Selwyn District Council
2 Norman Kirk Drive
PO Box 90
Rolleston, 7643

4 December 2024

D240002: New Zealand Transport Agency Notice of Requirement SH1 Rolleston Access Improvements Package 1 (Roundabout) - s92(1) RMA Request for Information (RFI) Response

Discipline:	CIVIL ENGINEERING
Drawing No.	3338703-10-CU-3523
Rev.	A

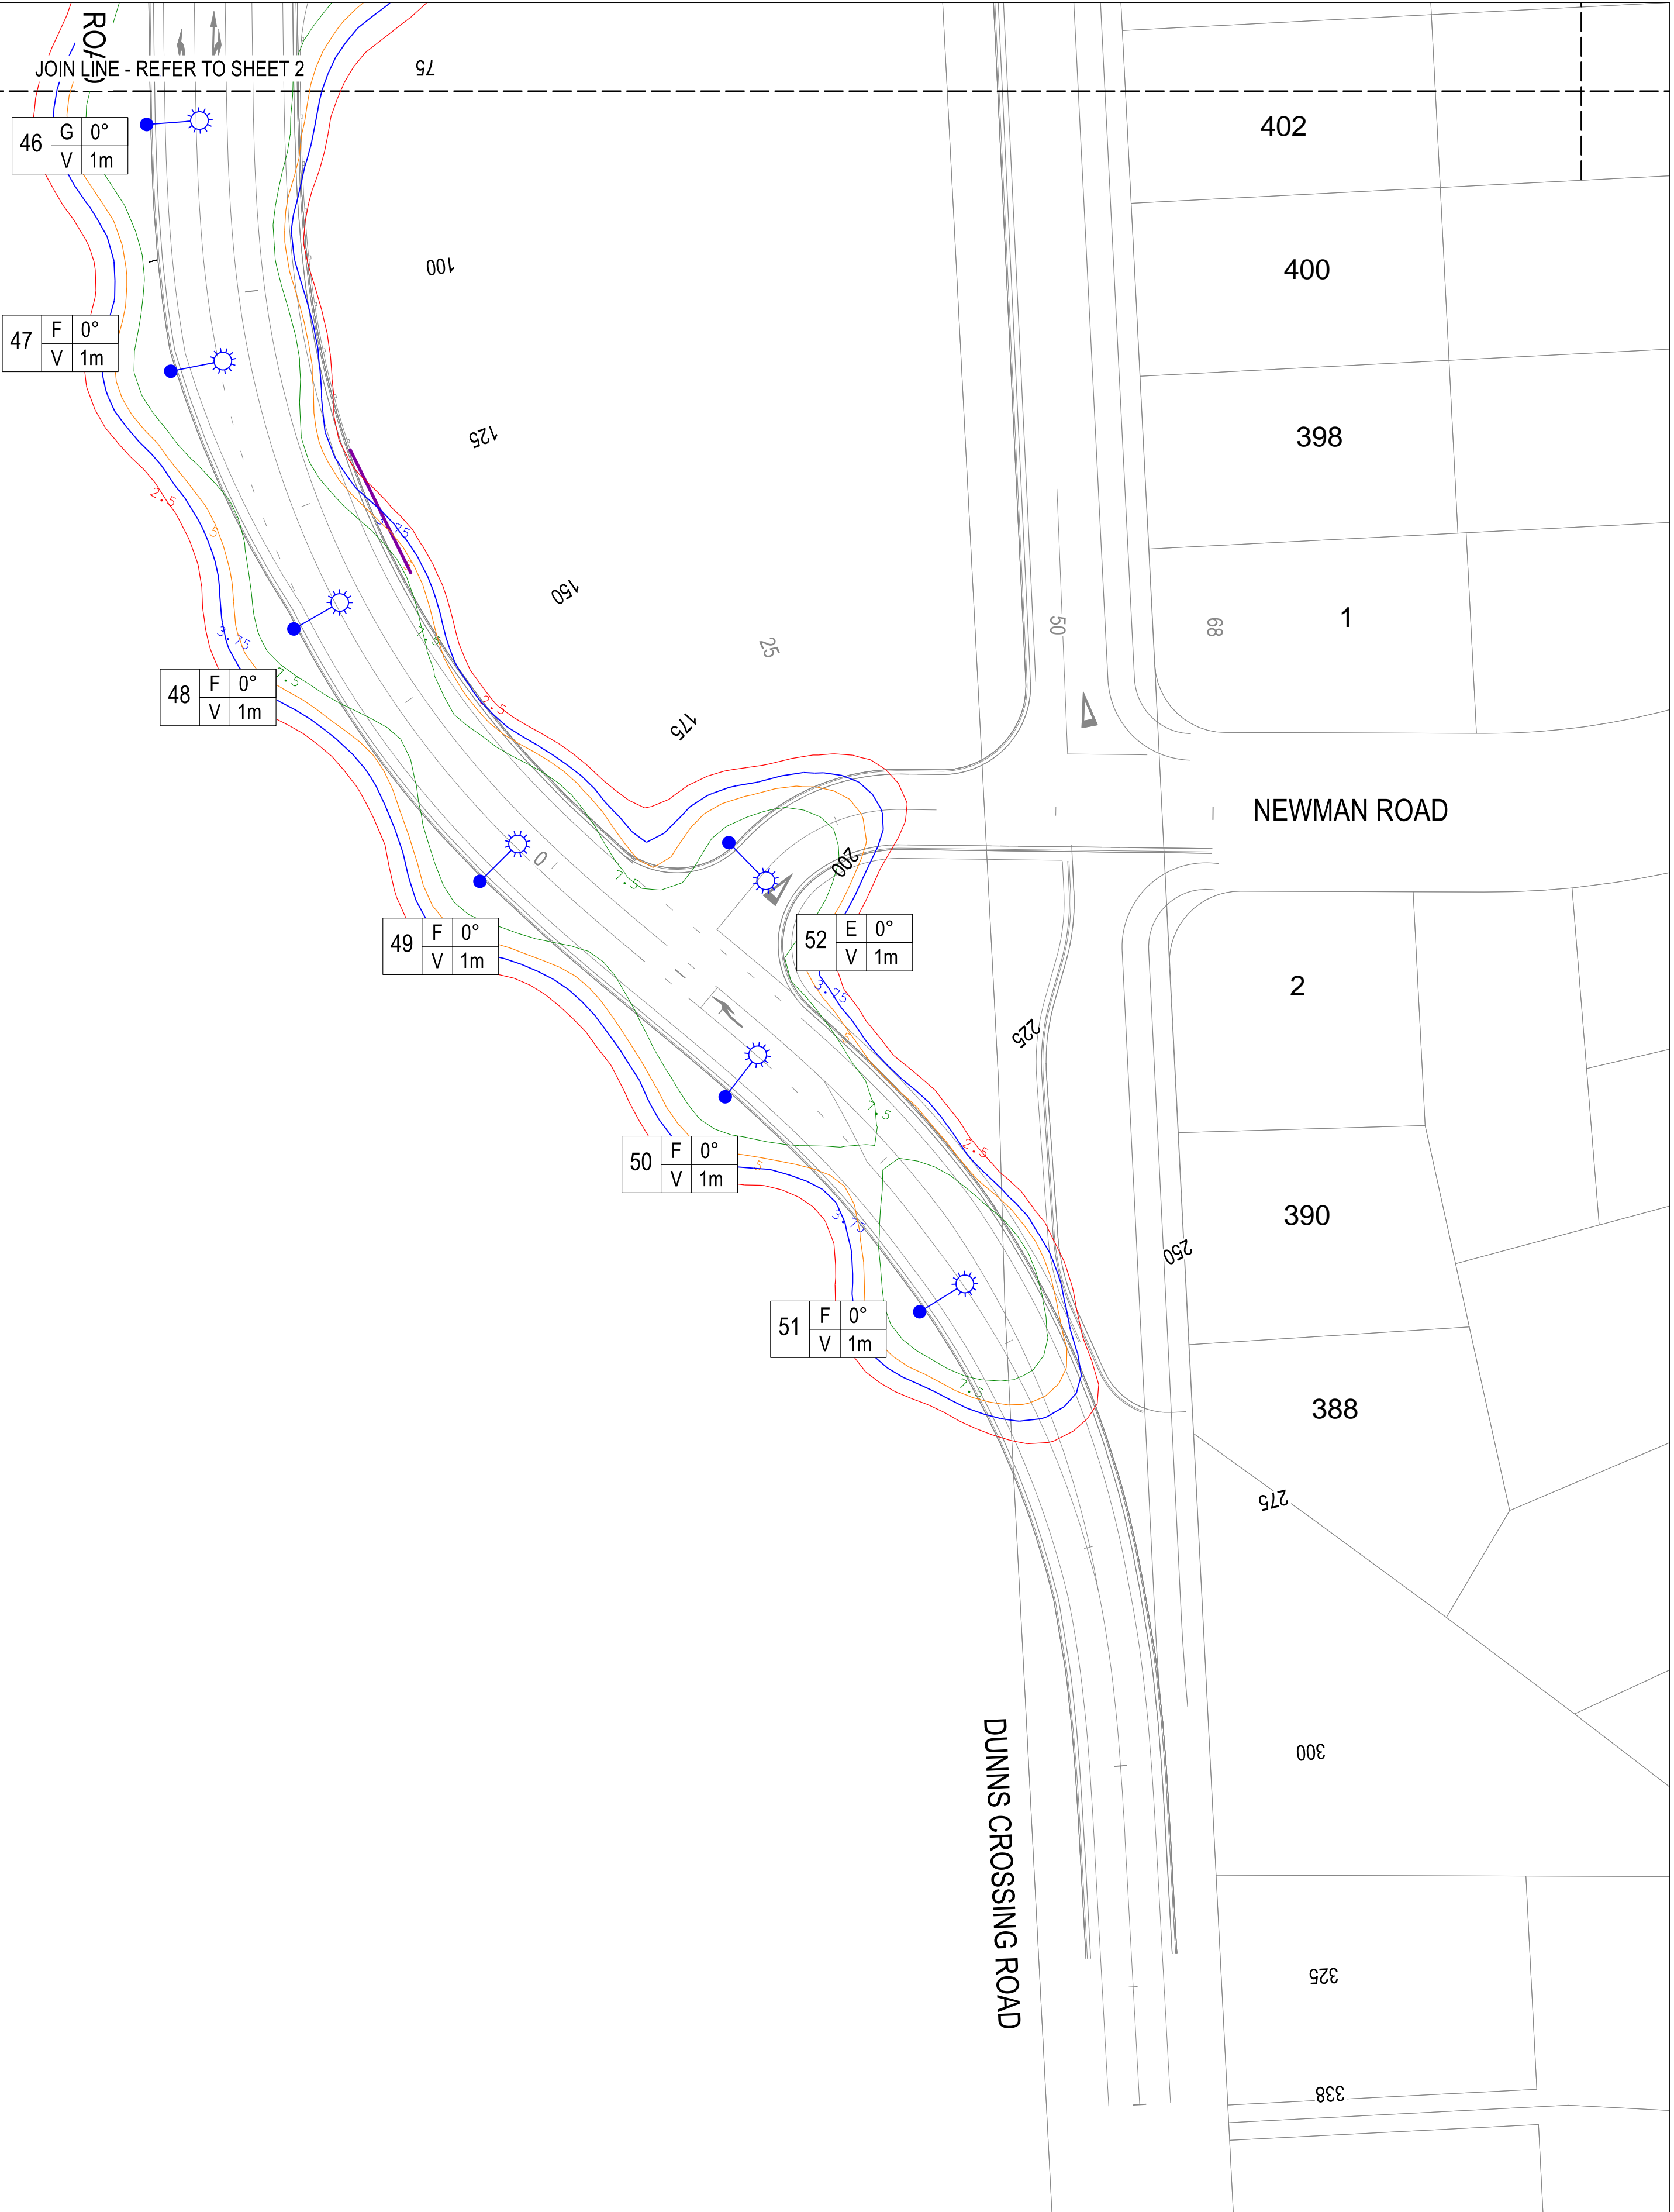
A15	NZTA M30 supersedes the lighting standard. 9.81 is a typo, and the target TI is less than 10%, which the design achieves in any case.
Q16	The TI and UWLR comments in Note 2 (above) are also applicable to drawings 3522, 3523 and 3524
A16	Refer to A15.
Q17	Drawing 3338703-10-CU-3521 - Luminance Calculation Summary table presents one calculation result, but what lane configuration does this calculation apply to? SH1 on either side of the RAB changes from a 4-lane divided carriageway to a 2-lane divided carriageway. The luminaire arrangement also changes from an opposite arrangement to a single sided arrangement at the eastern end SH1. There needs to be multiple luminance calculations to account for the different lane configurations and luminaire arrangements. Please get the lighting designer to confirm that the luminance calculations apply to all of the lane configurations (4-lane and 2-lane divided carriageways) and luminaire arrangements (SS and Opp) or supply additional calculation results to cover all arrangements.
